Preliminary Plat with Subdivision Ordinance Variances – Tuscan Village

PUBLIC STREET 2 SECTION SCALE: 1" = 5'

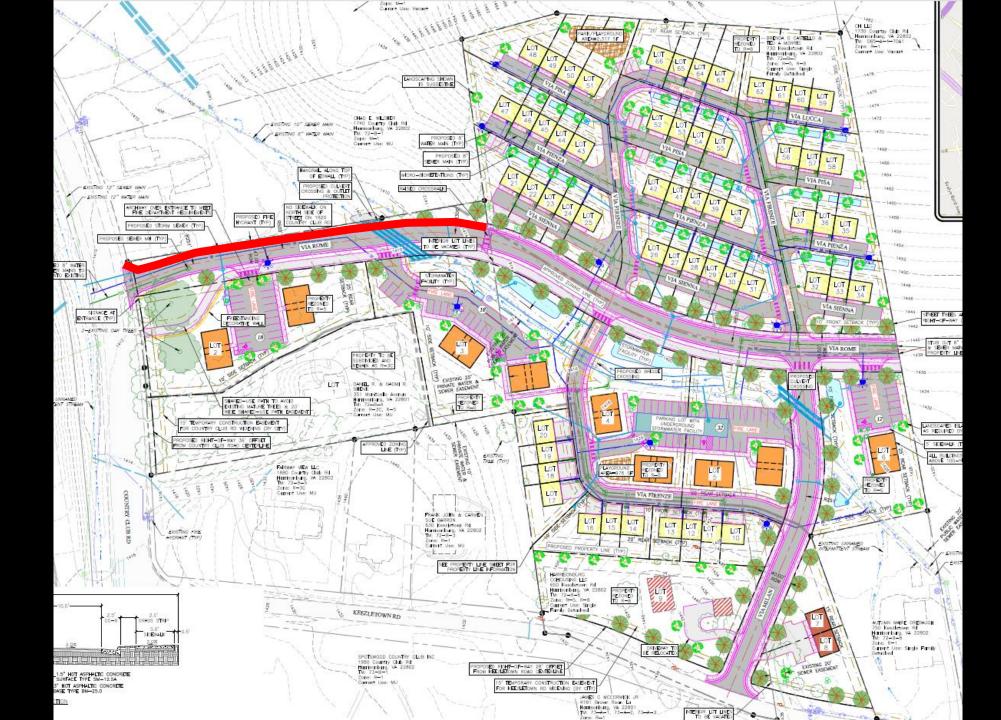
Staff and Planning Commission (4-0) recommends approval of the preliminary plat with requested variances from the Subdivision Ordinance with the following condition attached to the variance to not construct sidewalks on both sides of the new public street:

The developer shall install a raised crosswalk (or similar infrastructure as accepted by the Department of Public Works) in the location as generally depicted on the preliminary plat to serve pedestrians and to serve as a traffic calming measure. The design of the accepted infrastructure requires approval by the Department of Public Works.
